RE: Class 3 Site Plan Review, Class 1 Design Review, UGA, Class 2 Adjustments, and a Class 2 Driveway Approach Permit for 3480 Blossom Drive NE (AMANDA 22-123981-PLN)

I am reviewing your **Class 3 Site Plan Review, Class 1 Design Review, UGA, Class 2 Adjustments, and a Class 2 Driveway Approach Permit** application for completeness. The following information is required for staff to deem the application complete.

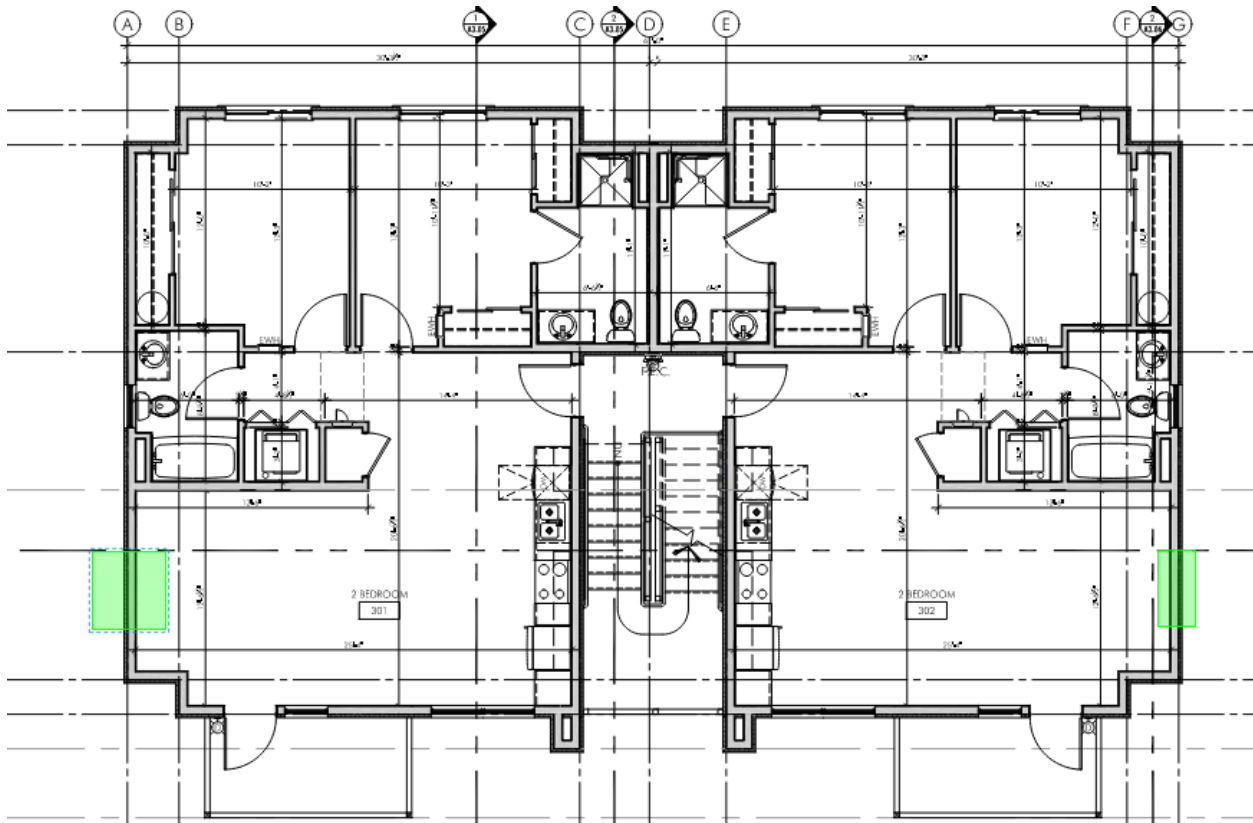
- (2) Design review standards for multiple family development with thirteen or more units. Please include the additional information on your site plan materials:
  - Pursuant to SRC 702.020(c)(1), all walls facing open space, parking areas and pedestrian paths shall have a window in habitable rooms. Bedrooms are habitable, which include closets. I have provided an attachment with window locations.

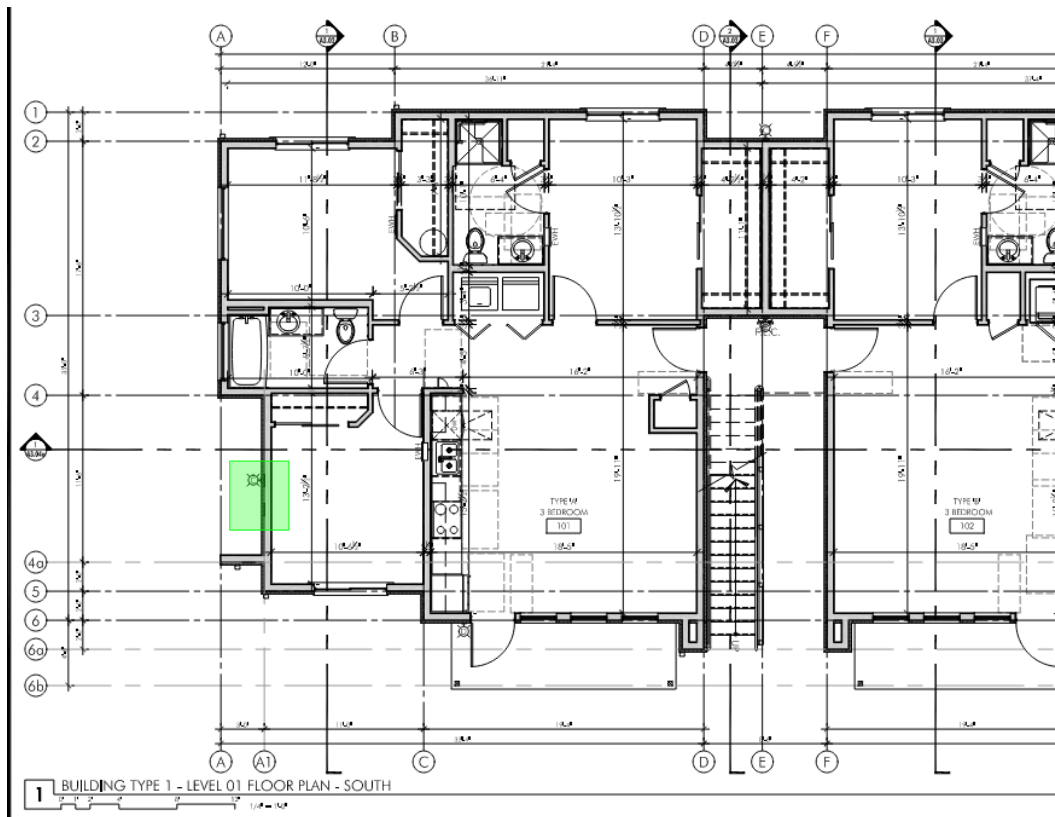
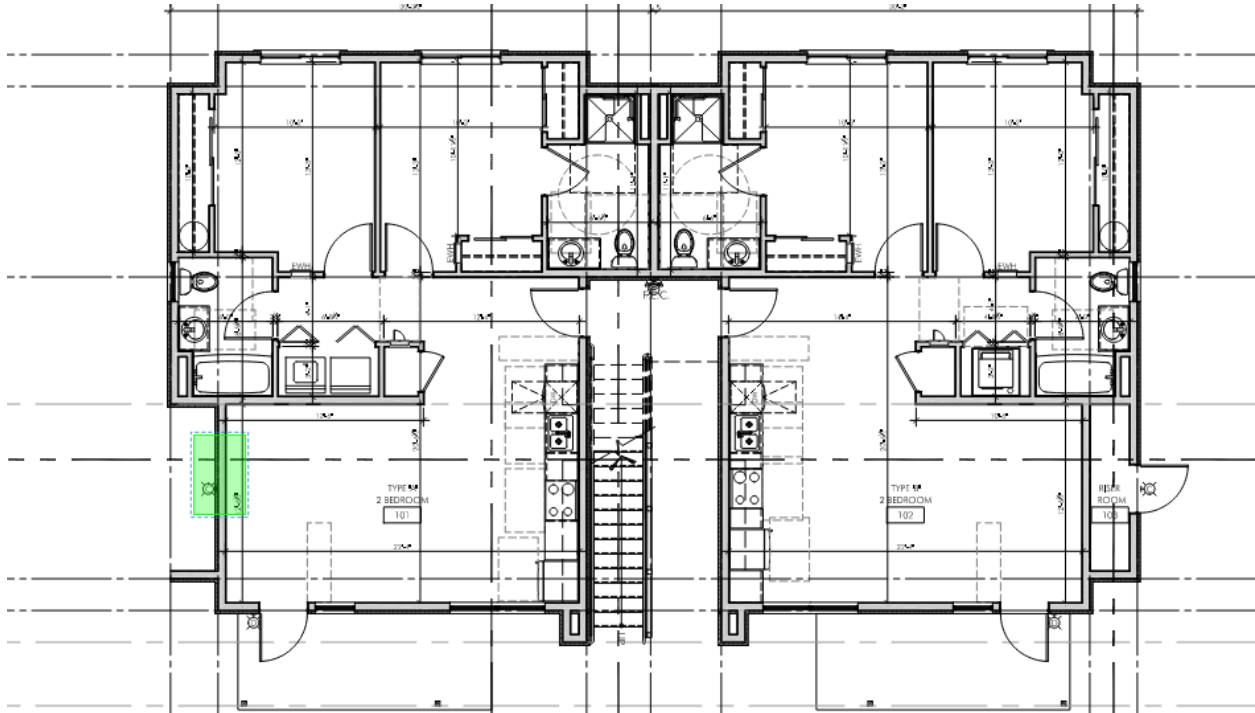
- (3) Missing Window. The applicant will need to revise the submitted floor plans to include windows on each wall of each room. These area's have been highlighted in green to provide further illustration.
